SUBJECT: UNITED STATES GEOLOGICAL SURVEY – ADDITIONAL CLARIFICATION
REQUESTED RE: RESPONSES TO THE U.S. NUCLEAR REGULATORY
COMMISSION REQUEST FOR ADDITIONAL INFORMATION DATED
SEPTEMBER 29, 2010 (TAC NO. ME1593)

REQUEST FOR ADDITIONAL INFORMATION

RENEWAL OF THE FACILITY OPERATING LICENSE

TRIGA REACTOR

Figure 1

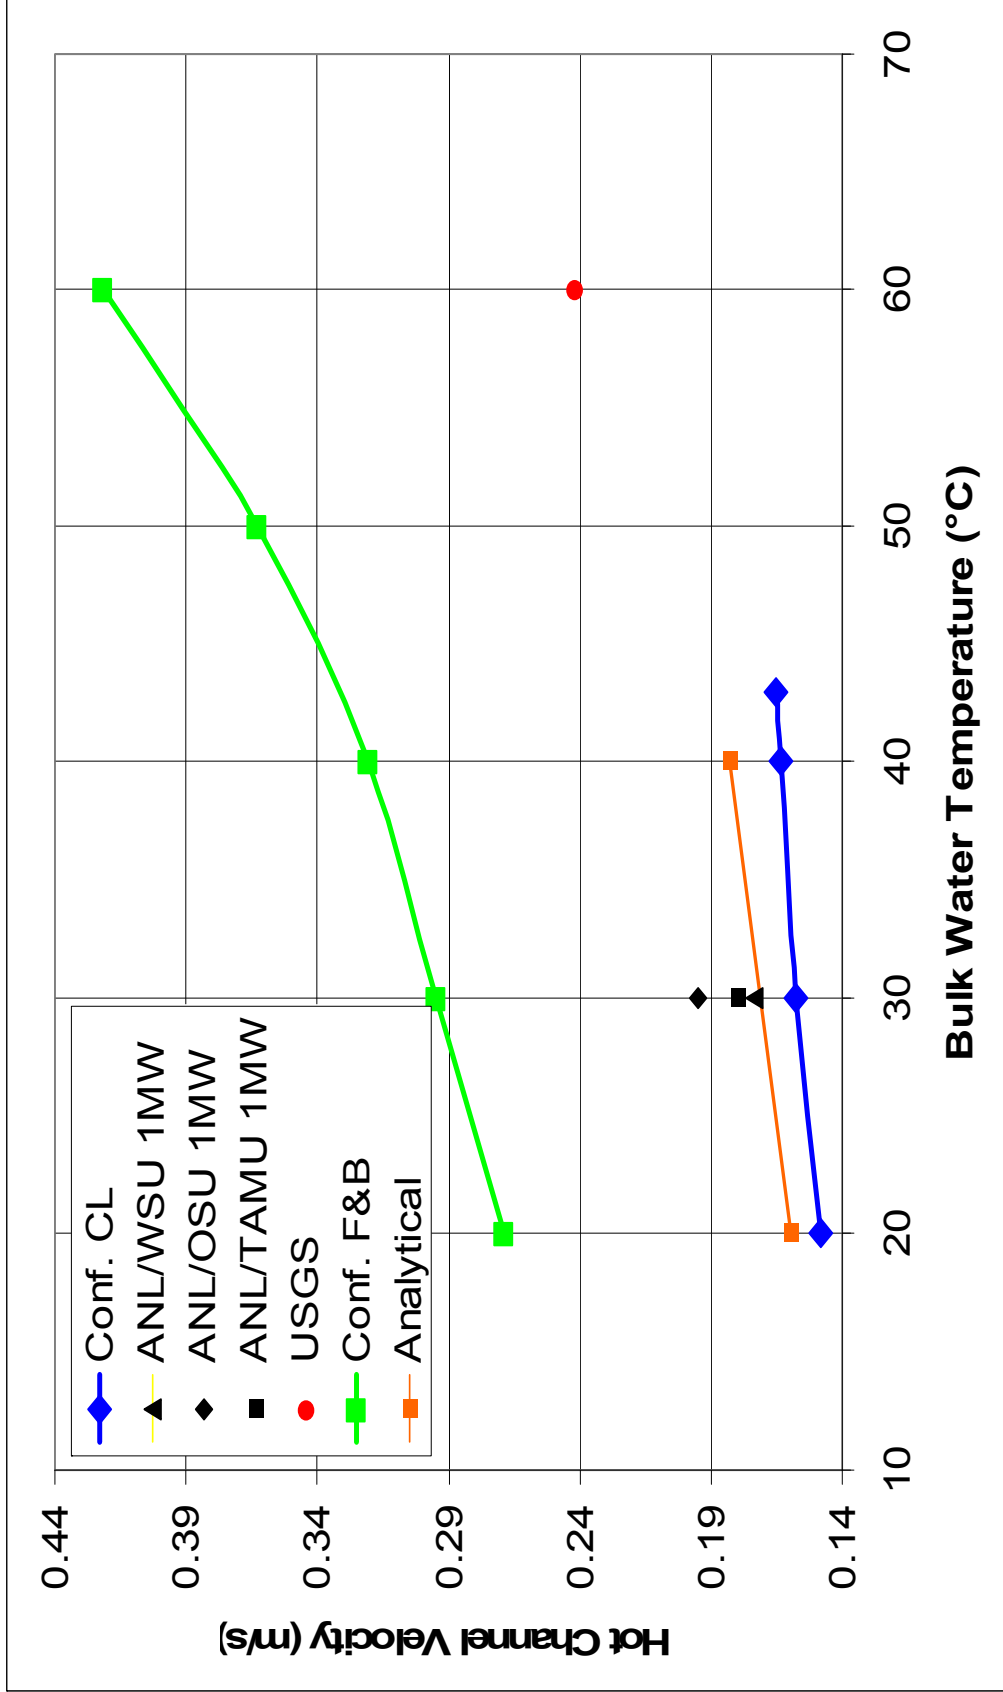
12	Describe the departure from nucleate boiling ratio (DNBR) analysis.	<ul style="list-style-type: none">• The NRC staff calculated a flow area per rod of 4.776 square centimeters (cm²) for the hot fuel element and 5.981 cm² for the average fuel element based on the core plate figure provided in your RAI response dated November 24, 2010 (ADAMS Accession No. ML103340090). These values differ significantly from the USGS RAI response values of 5.855 cm², and 8.382 cm², respectively. The NRC staff calculation results are provided in Table 1. Provide details of your calculations. [page 8]• The NRC staff confirmatory analysis of the LCC at the limited safety setting system steady state power of 1.1 megawatts (MW) using the TRACE computer code indicates significant flow oscillations occur when the core inlet temperature exceeds 42 degrees Celsius (C). Discuss the results of the GSTR RELAP analysis including any observed flow instabilities, and its affect on fuel temperature over the range of the core inlet temperature up to 60 degrees C. [page 9]• NRC staff performed their confirmatory analysis of the LCC using a closed loop (CL) model which produced coolant flow velocities that were consistent with independent analysis and measurements from similar research reactors and power levels and, consistent with the NRC analytical solutions for single phase natural circulation flow (see Figure 1). The NRC staff has also investigated the use of other modeling techniques (fill & break and large tanks) and determined that the coolant flow velocities were too high as compared to the CL benchmarks. The NRC staff's concern is that models using coolant flow velocities higher than actual may result in a non-conservative estimate of the DNBR. NRC staff review found that the GSTR flow velocities were approximately 30 percent higher than NRC staff results and the results of models for other facilities (see Figure 1). Please justify the use of the GSTR model given the apparent variance shown in Figure 1. [page 9]• Provide the maximum fuel temperature of the aluminum clad fuel element for the pulsing analysis. [page 9]• The temperatures in Table 3 do not match the temperatures provided in Figure 7. Explain the differences. [page 10]• The results of the "Characterization of the response of GSTR to a reactivity pulse and an uncontrolled rod withdrawal transient event" did not provide peaking factors or explain their use. Provide the peaking factors, and explain their use in the analyses (i.e., were they included in the model or applied to the results obtained from a model representing the average core or channel). [page 10]• For the uncontrolled rod withdraw analysis, explain if the withdrawn control rod continues until fully withdrawn, or if it inserts upon receiving the scram signal. [page 11]• GSTR provided a temperature of 1020 degrees Kelvin (K) and then converted it to 727 degrees C. The NRC staff converted 1020 degrees K to 747 degrees C. Explain the difference. [page 11]
